Access Compliance Report

Public Rights-of-Way (Curb Ramps)

Intersection ID: 3901	Main Street: RHIAN_BROOK_LN	Cross Street: BEATTIES_FORD_RD	Location: S
ADA ID: 4911F9479DB8	Ramp Type: PerpDiag	Initial Pass/Fail: Fail	Overall Compliance: No
Severity Score: 15			
Codes/Mitigation Info/Possible Solution		Field Measurements/Component Compliance

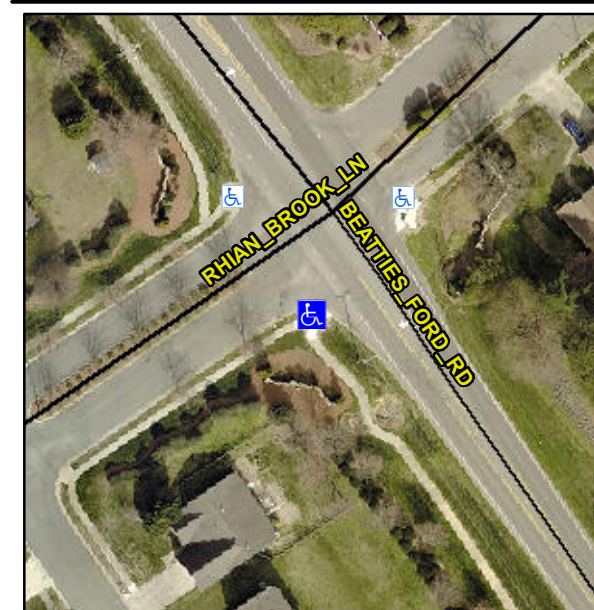
R302.7

Remove & Replace Curb Ramp With Two New Directional Ramps or Equivalent.
